MARYLAND STATE DEPARTMENT OF HEALTH

HOWARD COUNTY
BUREAU OF ENVIRONMENTAL HEALTH
997-2330

MEMO FOR THE RECORD

The Heritage, Lot 55
4100 Sharp Road
A-21887

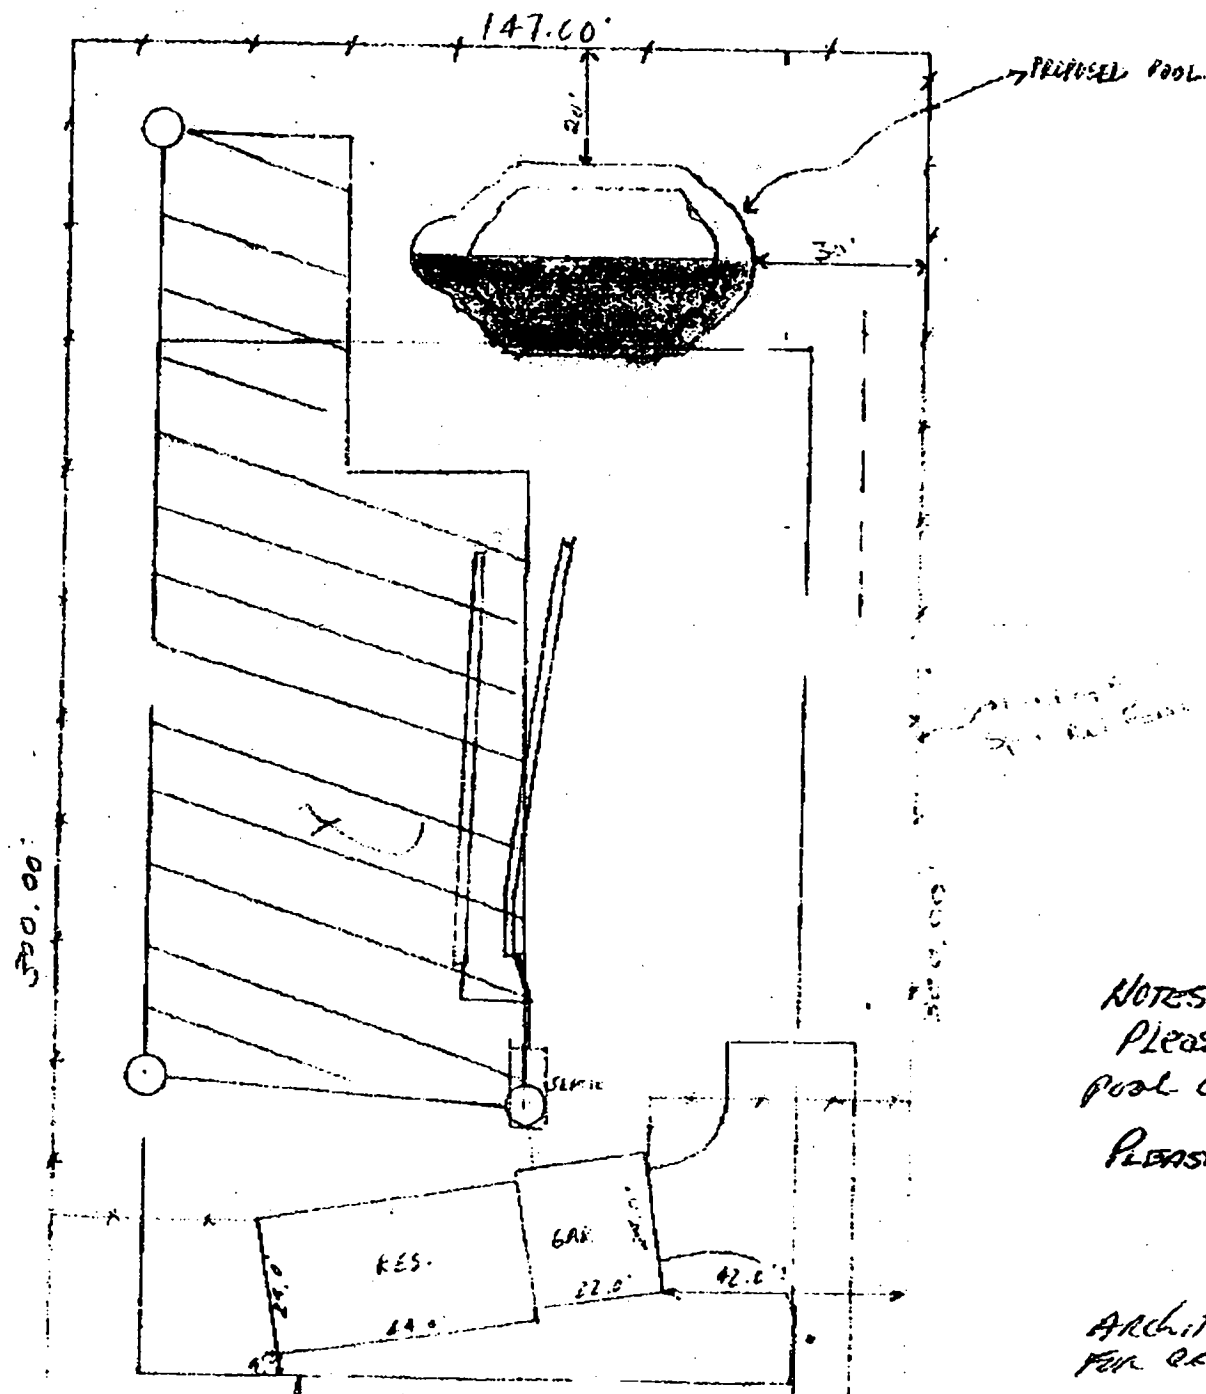
It appears that the septic easement is only 10 ft. to 20 ft. from the rear of the house and there would be no room for any additional structure except for on the left side of the house. Approximately 20 ft. exists between the house and building restriction line along the left lot line.

Another concern was the pool location at the center rear of the property. It appears that in 1987, a pool was permitted and intrudes into the sewage disposal easement by about 2000 sq. ft. It is unclear if 10,000 sq. ft. remains in the current sewage disposal easement. Based on these factors, I suggested that no infringement of a deck would be allowed into the sewage disposal area. I did state that a raised deck of 10 feet or so might be considered if it were to the far left rear corner of the house and was at least 10 ft. from the sewage disposal area, assuming full access to the field and septic tank could be attained by a scavenger or septic installer.

On January 12, 1994, Ms. Knotts was called in response to another concern. She asked if a chain fence would be permitted around the pool as there was only a split rail fence around the property to keep children from injury in the pool. Ms. Knotts felt that concrete footers would need to be poured to support the pool fence and they would most likely be in the existing sewage disposal area. The depth to the trench inlet is 4 ft. and an excavation of 2 or 3 ft. above the trenches could present damage to future or existing trench design.

According to the real estate information, the house contains five bedrooms. The septic system was generously sized for four bedrooms with a 1500 gallon septic tank installed. The septic system is undersized for five bedrooms.

REVISED.
11/22/00

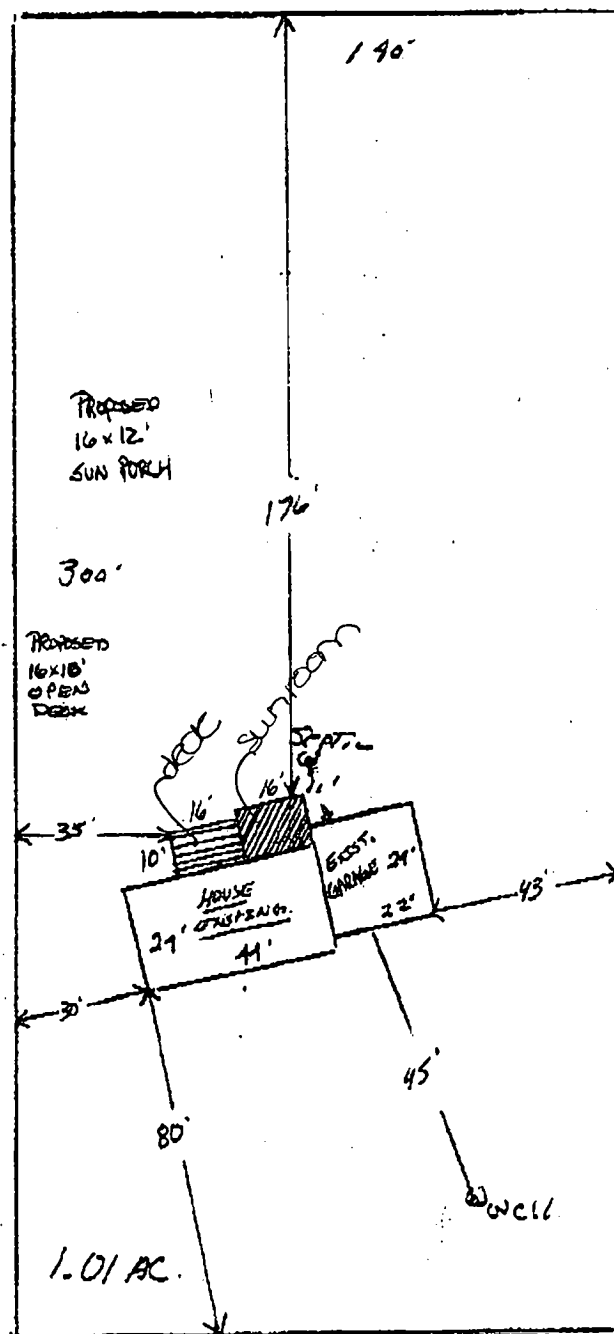
11/22/00 B00127186
Spoke to Greg Falter
I approved this revised
plan (sunroom is
to be 7' off septic
tank, 8' high, posts
2' in from edge)
I explained that revision
to original BP must
be submitted prior to
HD sign off to DLP.
SKC

REVISED
12/19/00

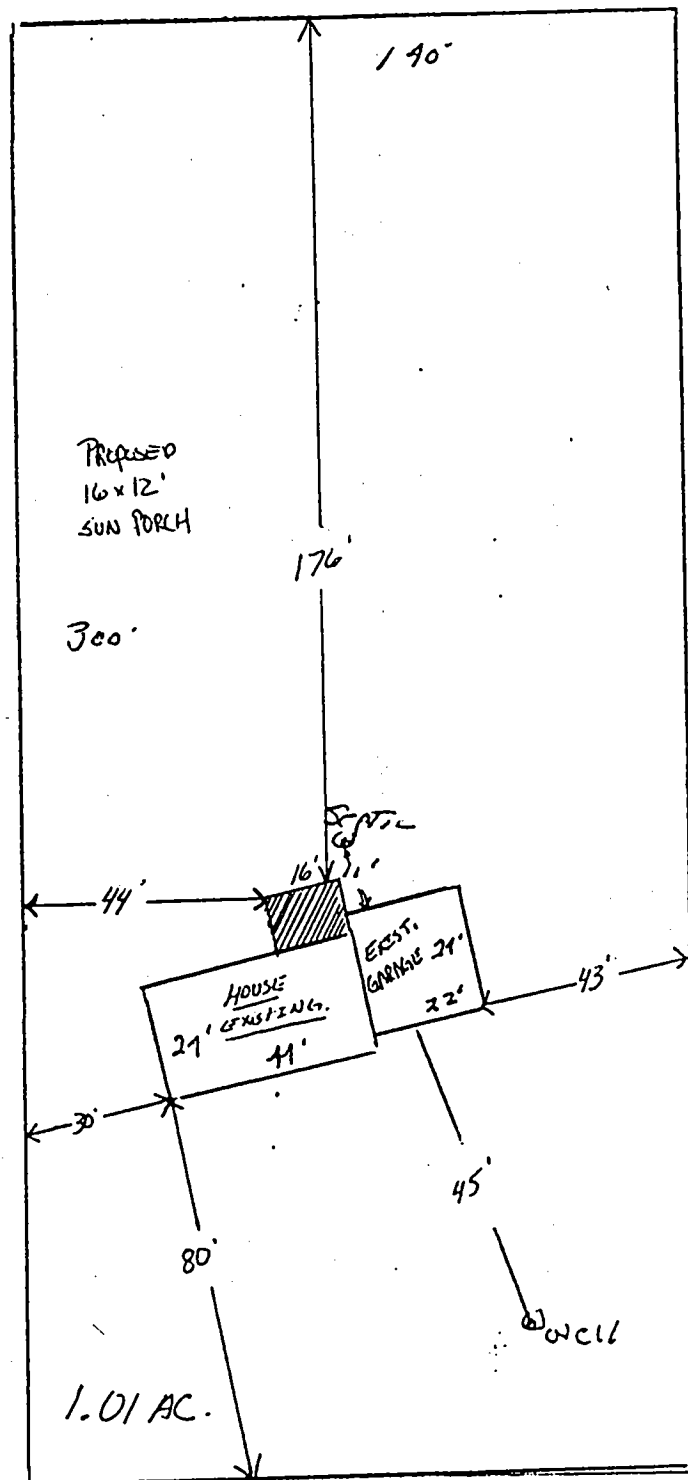
Enclosed, please find four (4) copies of a revised plot plan for
permit # B00127186 Geibel, steven 4100 sharp rd.glenelg md. the customer
has decided to omit the open deck (16 x 10) from this project.

Comments: Revised location
for addition/sun porch +
removal of deck

12/26/00 Revision to only sunroom addition or
as presented. Original BP application
corrected as a result of this submission
(XO)
